City of Portland, Maine – Building or Use Permit Application 389 Congress Street, 04101, Tel: (207) 874-8703, FAX: 874-8716

Permit No: **980254**

BUILDING PERMIT REPORT

DATE: 19 March 98 ADDRESS: 174 Curtis Rd. (389-G-025)
REASON FOR PERMIT: To Construct a 18x24' addition
BUILDING OWNER: Mull, Charles & Jennifer
CONTRACTOR: W.W. Gagnon
PERMIT APPLICANT: Butch Gagnon
USE GROUP R-3 BOCA 1996 CONSTRUCTION TYPE 5-B

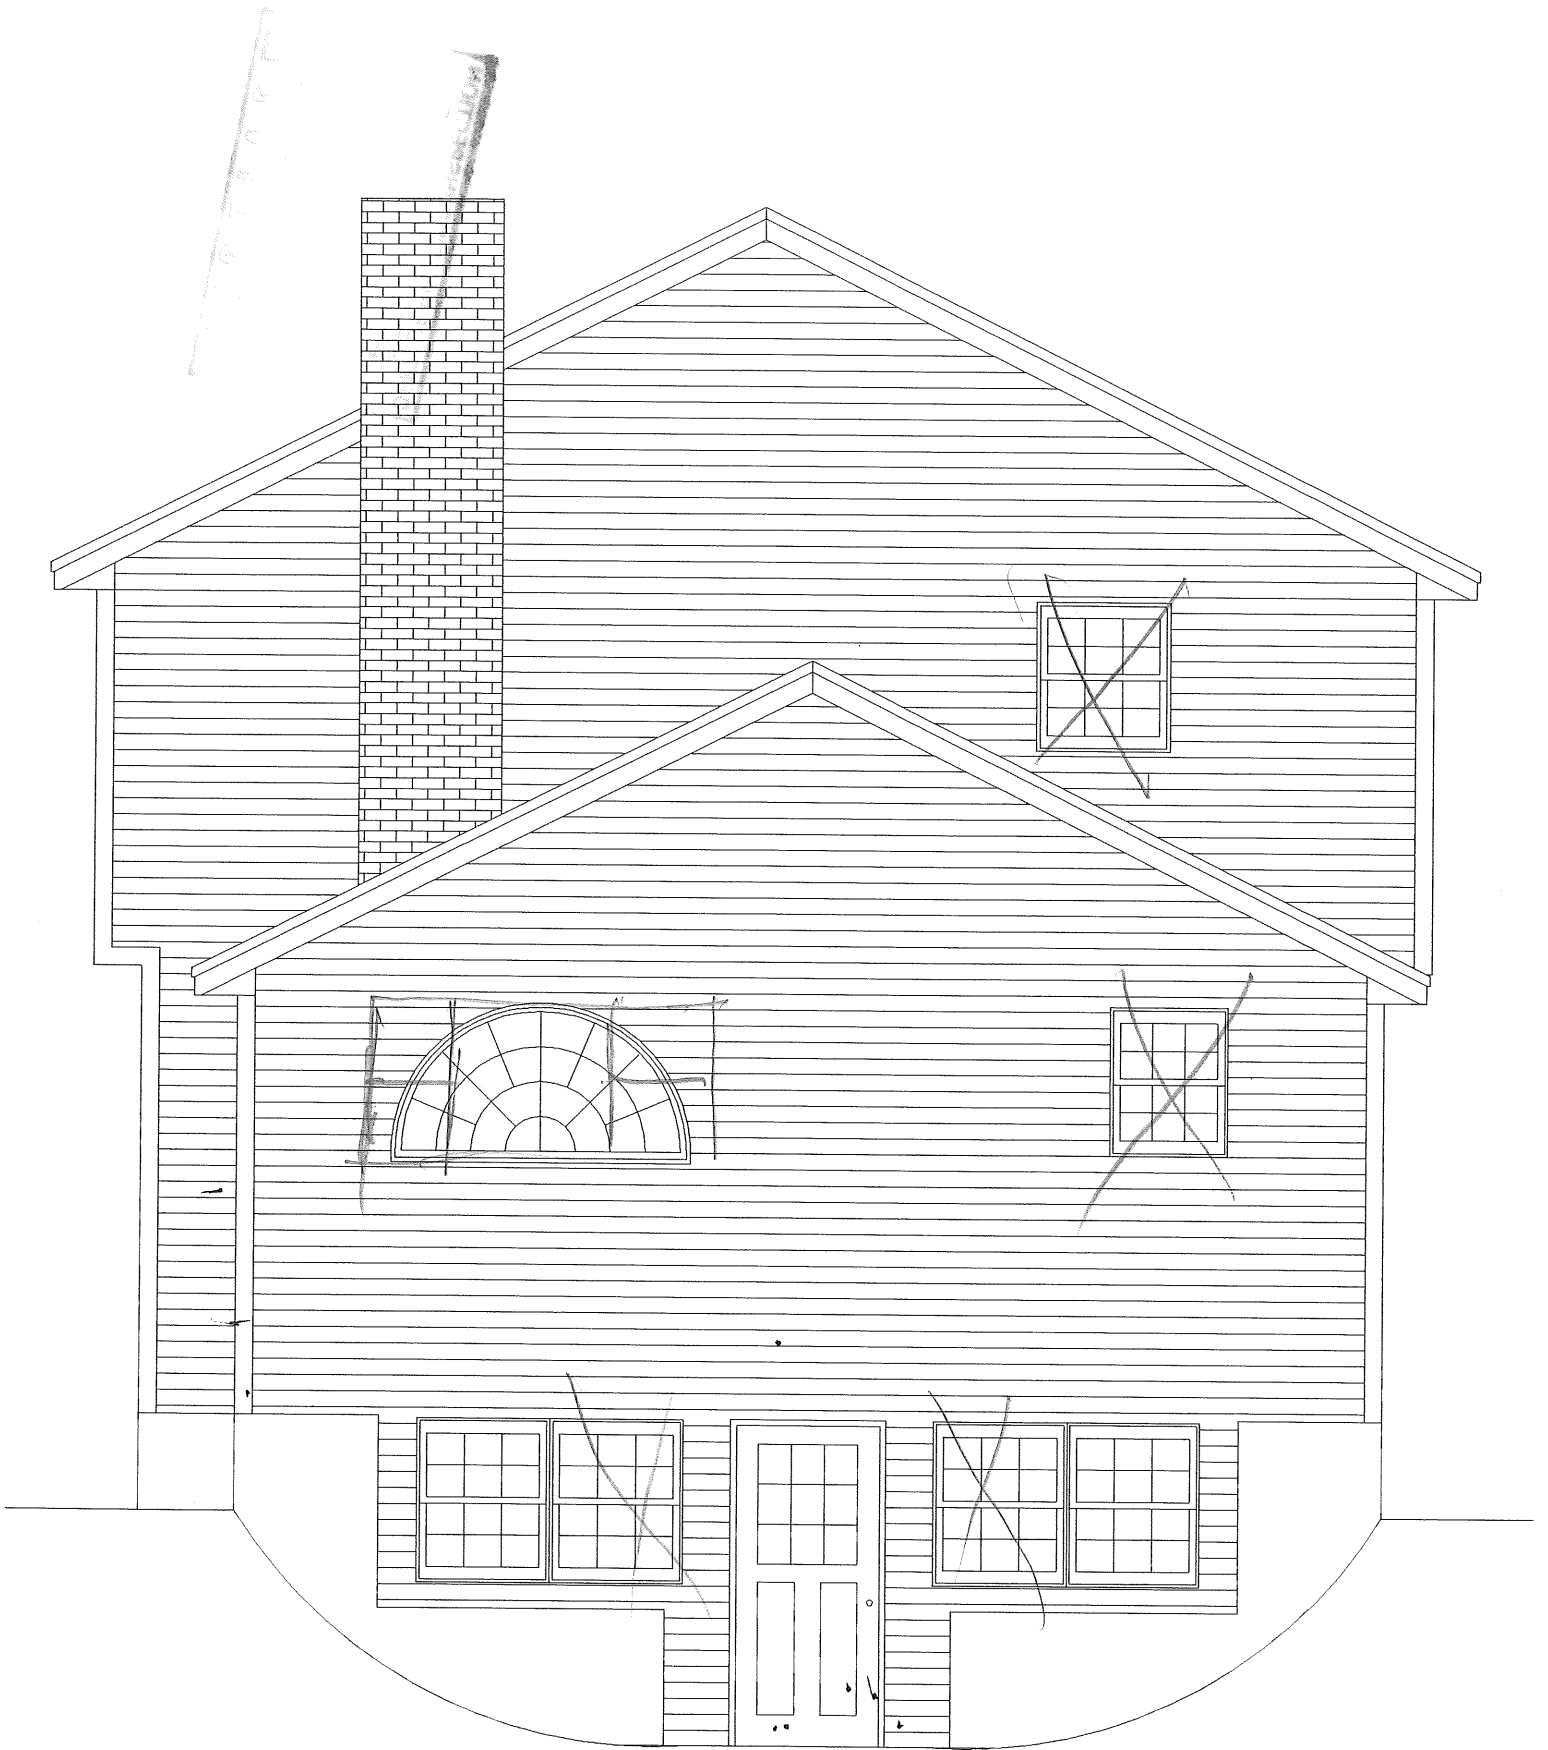
→ notations
 per Butch Gagnon
 telephone call
 giving me the
 setbacks 3/18/98

remeasured
 by contractor
 & shows
 22' only
 3/18/98 9001

notified the contractor
 that I needed front &
 rear setbacks

Addition Floor Plan
 Scale 1/4" = 1'

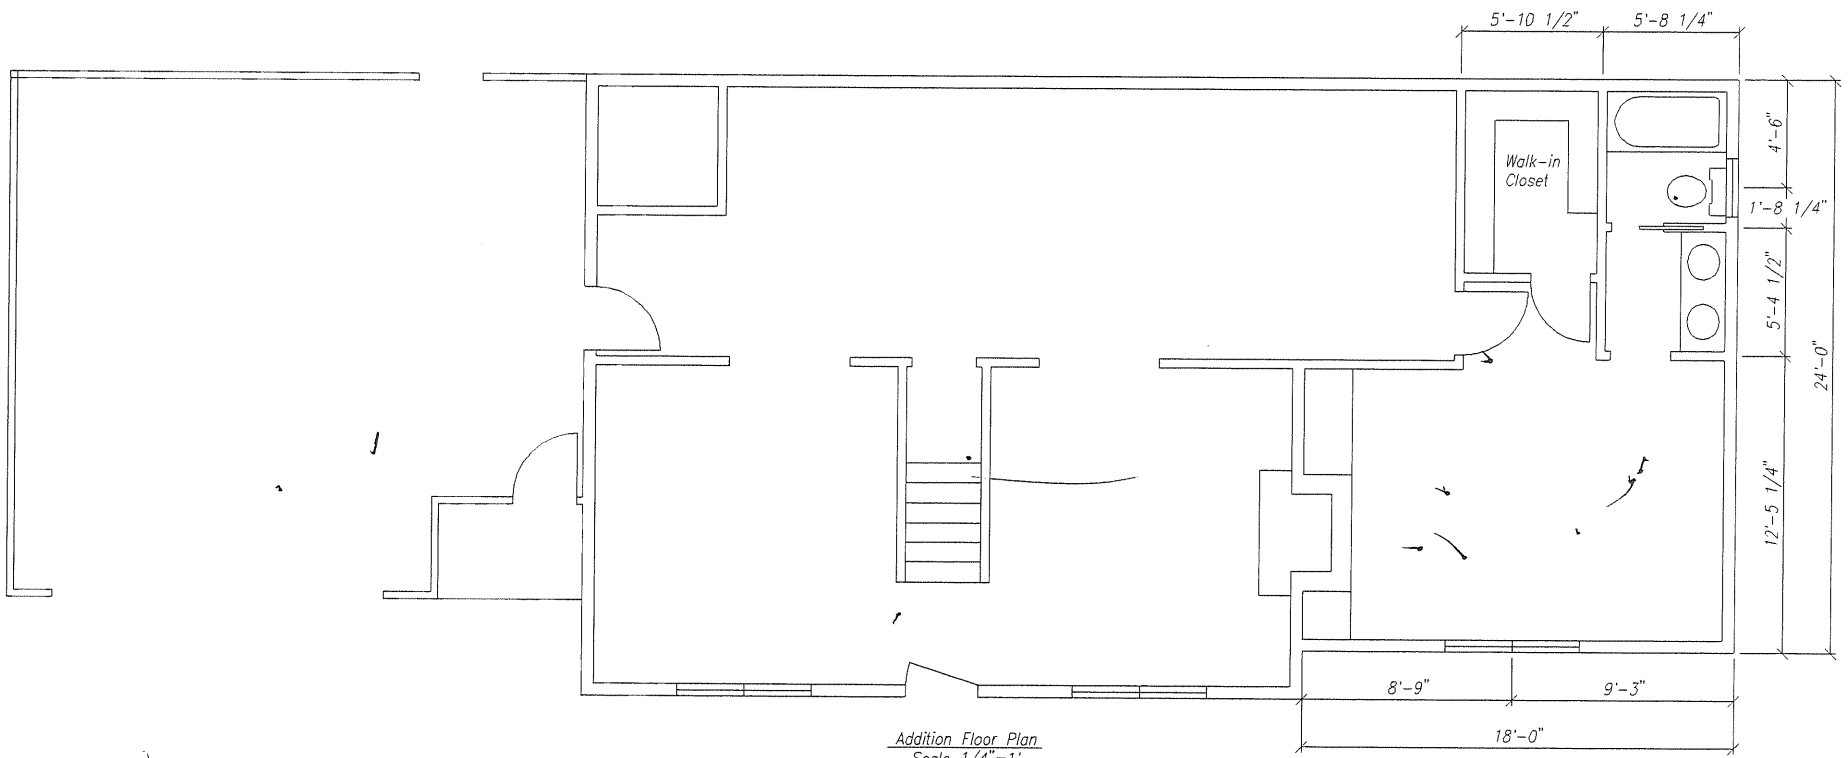
- X 29. As per our conversation on 19 March 1998 you will submit a design sheet on the proposed Floor Trusses to this office before work begins
30. The proposed Addition ^{Foundation} must be pinned into the existing Foundation.

31. Waterproofing & Damp proofing & Foundation drains shall be accordance with sections 1813.0 & 1813.5.2 of the City's building Code.
32. You stated you would be cutting a door through the existing Foundation - therefore a Lintel must be designed for this opening.
